**STAFF REPORT
KETCHUM PLANNING AND ZONING COMMISSION
SPECIAL MEETING OF APRIL 27, 2021**

- PROJECT:** Westcliff Townhomes
- FILE NUMBERS:** P21-019 & P21-008
- APPLICATION:** Design Review, Townhouse Subdivision Preliminary Plat, and Phased Development Agreement

- REPRESENTATIVES:** Peter & Kristin Anderson, Anderson Architecture, P.A. and Garth McClure, Benchmark Associates
- OWNER:** Westcliff LLC
- LOCATION:** 106 & 110 Rember Street (Bavarian Village Subdivision: Lot 3B)

LANDSCAPE PLAN
L-3.0

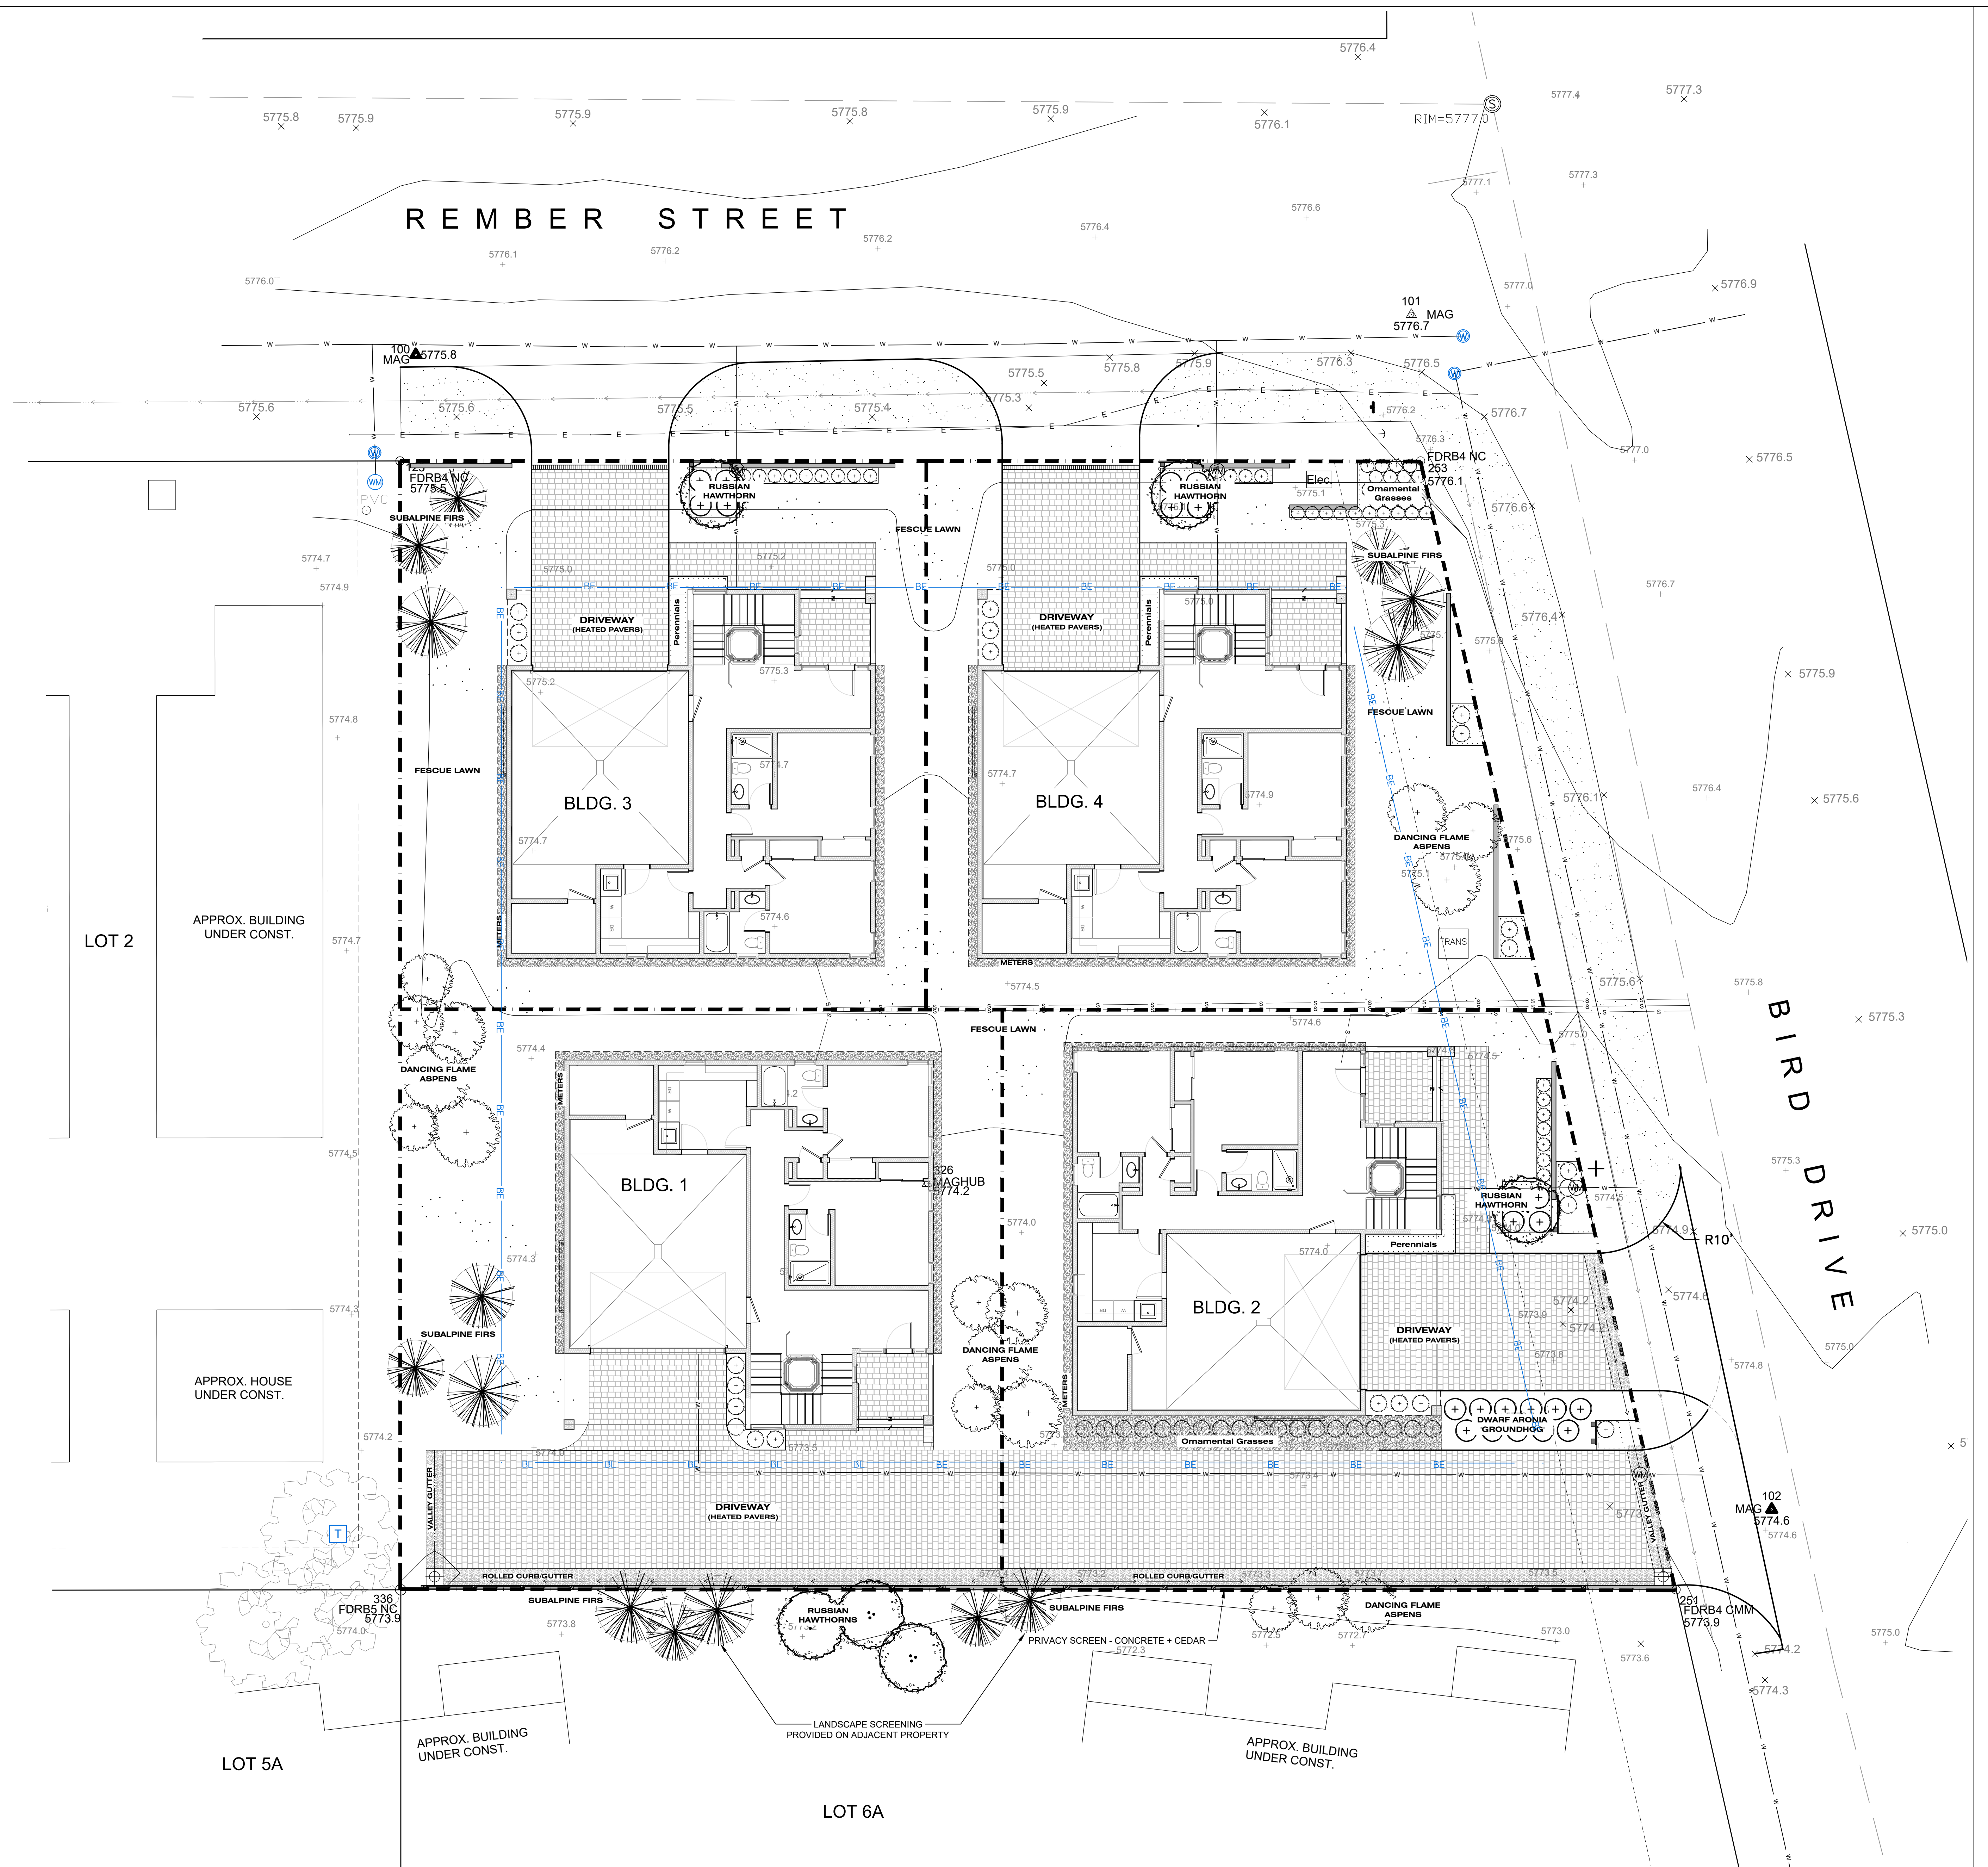
The project plans indicate the installation of new transformer to serve the townhome development on the southeast corner of subplot 4. As indicated on Sheet L-3.0, the transformer is proposed to be screened from public view by a 3-foot tall concrete site wall and 3 aspen trees. The existing sector box at the northeast corner of the project site at intersection of Rember Street and Bird Drive is proposed to be screened by ornamental grasses and a 3.5-foot-tall concrete site wall. The applicant has submitted a letter from Idaho Power dated April 21, 2021 stating that the proposed screening does not comply with their clearance requirements. The applicant must propose a solution that complies with all Ketchum Municipal Code screening standards and Idaho Power Company clearance requirements.

| | | | Staff Comments | The project does not propose any accessory structures. The project’s site improvements include landscaping, privacy fences, and concrete site walls. The landscape plan is provided on Sheet L-3.0 of the project plans (Exhibit A). Landscaping includes evergreen trees (Subalpine Fir), deciduous trees (Russian Hawthorn and Aspen), shrubs groupings, and ornamental grasses. The proposed landscaping softens the rectangular mass of each townhome unit and provides screening between the project and neighboring developments. The applicant has proposed a series of concrete site-walls along the front and street side property lines that frame the townhome development. All site-walls are less than 4 feet in height and are softened by shrubs and ornamental grasses. The applicant has proposed a 6-foot-tall privacy fence to screen the private driveway accessing subplot 1. The privacy screen is comprised of a stained concrete base with steel posts and cedar boards. An elevation of the privacy screen is provided on Sheet L-2.0 of the project plans. The site walls’ and privacy fences’ concrete, steel, and cedar complement each townhome units’ natural exterior materials and colors. The concrete site walls and privacy fences comply with the maximum height permitted for fences, hedges, and walls pursuant to KMC §17.124.130. |

| | | | Staff Comments | The landscape plan is provided on Sheet L-3.0 of the project plans (Exhibit A). Landscaping includes evergreen trees (Subalpine Fir), deciduous trees (Russian Hawthorn and Aspen), shrubs groupings, and ornamental grasses. The proposed landscaping softens the rectangular mass of each townhome unit and provides screening between the project and neighboring developments. The applicant has proposed a series of concrete site-walls along the front and street side property lines that frame the townhome development. All site-walls are less than 4 feet in height and are softened by shrubs and ornamental grasses. The applicant has proposed a 6-foot-tall privacy fence to screen the private driveway accessing subplot 1. The privacy screen is comprised of a stained concrete base with steel posts and cedar boards. An elevation of the privacy screen is provided on Sheet L-2.0 of the project plans. The site walls' and privacy fences' concrete, steel, and cedar complement each townhome units' natural exterior materials and colors. The concrete site walls and privacy fences comply with the maximum height permitted for fences, hedges, and walls pursuant to KMC §17.124.130. |

14. All utilities, including transformers, must be screened and concealed from public view pursuant to Ketchum Municipal Code §17.96.060.D2. The applicant must propose a solution for the new transformer that complies with all Ketchum Municipal Code standards for utility screening and Idaho Power Company requirements for clearance. The applicant must indicate the proposed location and siting of the new transformer on the project plans with written confirmation of Idaho Power’s approval for final review and approval by Planning Staff prior to issuance of a building permit for the project.
